**Braddon Commercial Area Planning Study
Draft Report 2007**

Braddon Commercial Area Planning Study

Braddon Commercial Area – Draft Planning Study

ELOUERA STREET CROSS SECTION

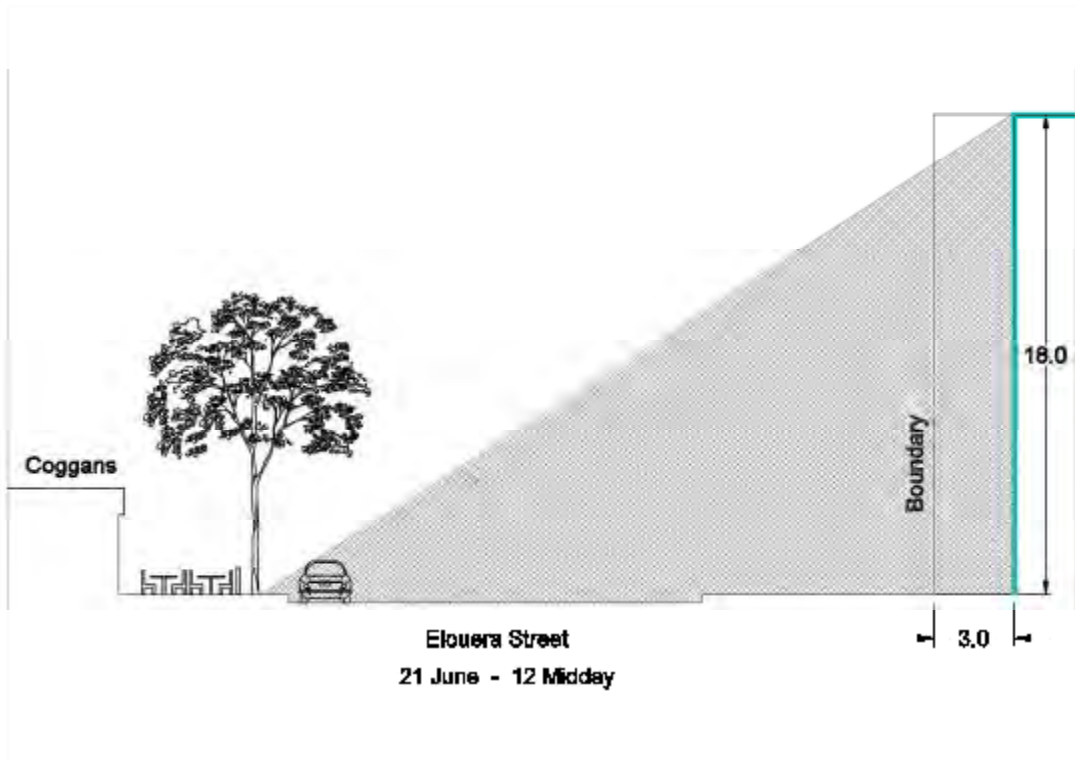
We are able to advise that, even under the worst case scenario with a six storey building set back 3 metres from the boundary of block 9, there is no shadow on the Coggans eating area in mid-winter. We have prepared shadow diagrams to illustrate this which are attached for your review. The cross section in particular illustrates the fact that the outdoor seating area is free of shadow at midday in mid-winter. The diagrams have been prepared using Autocad 2008, configured for Canberra's latitude and longitude, and we are confident of their accuracy. In light of this information we trust that you will be able to apply the six storey limit to blocks 8 and 9, and do so with confidence that there will be no impact.

SHADOW DIAGRAMS

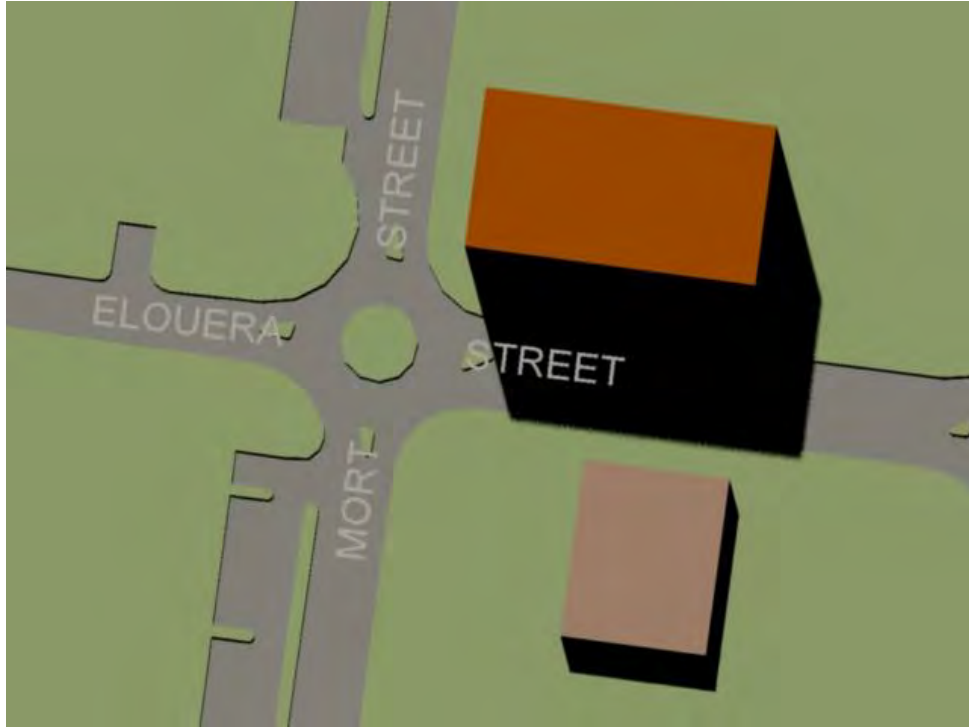
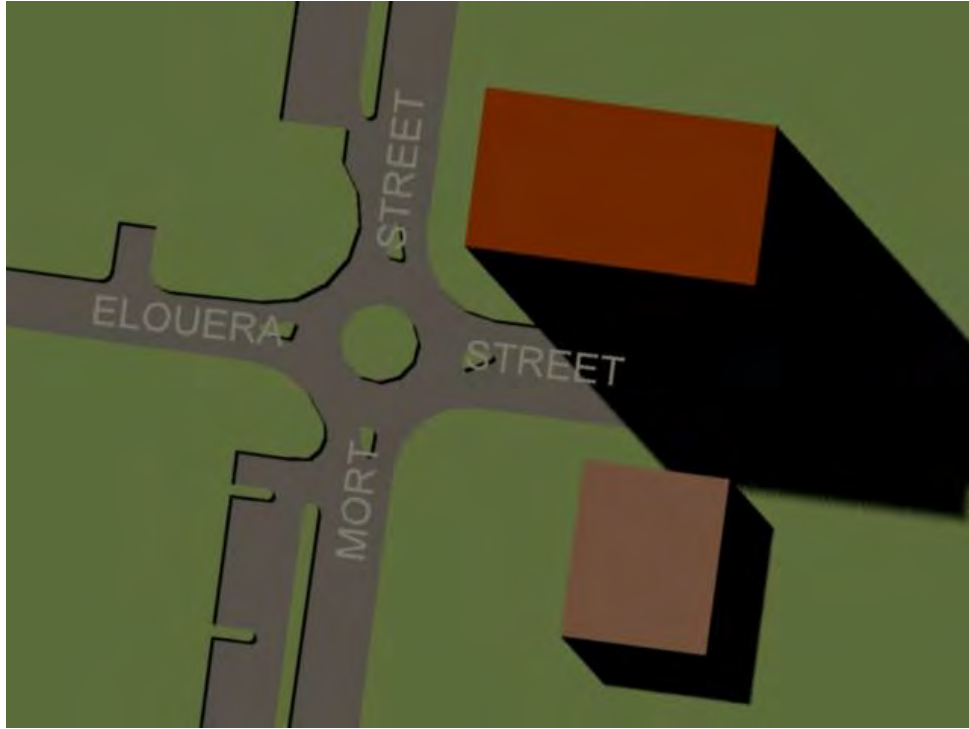
Six storey height limits, extending one or two blocks from corners are proposed on the northern and southern ends of sections 28 and 29 and on the northern ends only of sections 20 and 21. The southern end of section 20 is very similar to the southern end of sections 28 and 29 and we propose that the six storey limit be applied to blocks 8 and 9 of section 20 in the same way that it is

applied to blocks 8 & 19 of section 28 and blocks 13 & 12 of section 29. The three sites are effectively identical.

We note that overshadowing is considered to be a key issue and that this is the basis for decisions on height allocation. It may be that you have considered that, because Eloura Street is narrower than Cooyong Street the overshadowing impact will be more severe. In particular we assume that it would be considered desirable to maintain high levels of solar access to the southern footpaths in Eloura Street including the outdoor eating at Coggans café.
